**CITY OF RAMSEY LAND USE APPLICATION**  
**TECHNICAL REVIEW FILE**

<b>DATE</b>	NOVEMBER 28, 2018	<b>PROJECT ADDRESS</b>	15153 NOWTHEN BLVD  LOT 25, BLOCK 1 HARVEST ESTATES
<b>PROJECT. TITLE</b>	HARVEST ESTATES – MEADOWBROOK DEVELOPMENT – SKETCH PLAN		
<b>ESCROW #</b>	116696		
<b>DEPARTMENT:</b>	Community Development: Planning Division (Zoning Code)		
<b>TECHNICAL REVIEWER:</b>	Name: Chloe McGuire Brigl Phone: (763) 433-9821 Email: <a href="mailto:CMcGuire@CityofRamsey.com">CMcGuire@CityofRamsey.com</a>

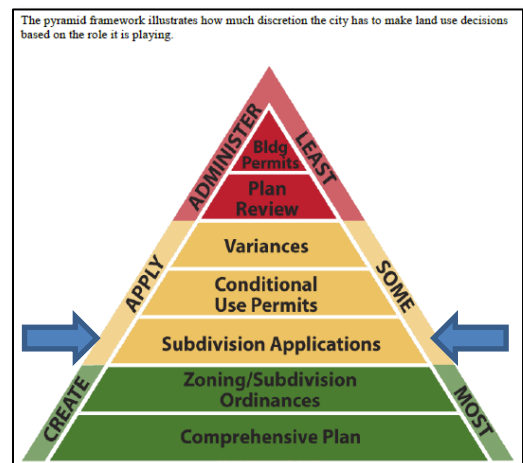
1. Name of plat is shown as “Harvest Estates.” As Harvest Estates was already platted, the name of this subdivision will need to be Harvest Estates 2<sup>nd</sup> Addition, or a new development name.
2. A standard drainage and utility easement shall be shown on all lots as well as provided over all stormwater ponds, wetlands, and the 16.5’ wetland setback area now required by City Code.
3. Add name of streets.
4. Preliminary Plat submittal will need to clearly label any wetlands and the sixteen and a half (16.5) foot wetland setback.
5. Parks and Recreation Commission to discuss possible trail obligations or deferral (cash in lieu of construction).

**General.** The Sketch Plan proposes re-platting Lot 25, Block 1, Harvest Estates into fifteen (15) new single family, detached lots. The lots would be accessed by the extension of 152<sup>nd</sup> Ct NW and 152<sup>nd</sup> Ln NW. The sketch plan also shows access off Nowthen Blvd NW that will need to be finalized with the preliminary plat.

**Lot Sizes.** The minimum lot size for the R-1 Residential District (MUSA) is 10,800 square feet with a lot width of 80 feet measured at the front yard setback.

Lot Size Requirements		
	Required	Proposed
Lot Size	10,800 square feet	Doesn't meet requirement: Lot 1, Block 1 - 10,536 sq. ft. Remaining lots meet requirements.
Lot Width	80 feet	Proposed 65 feet for all lots
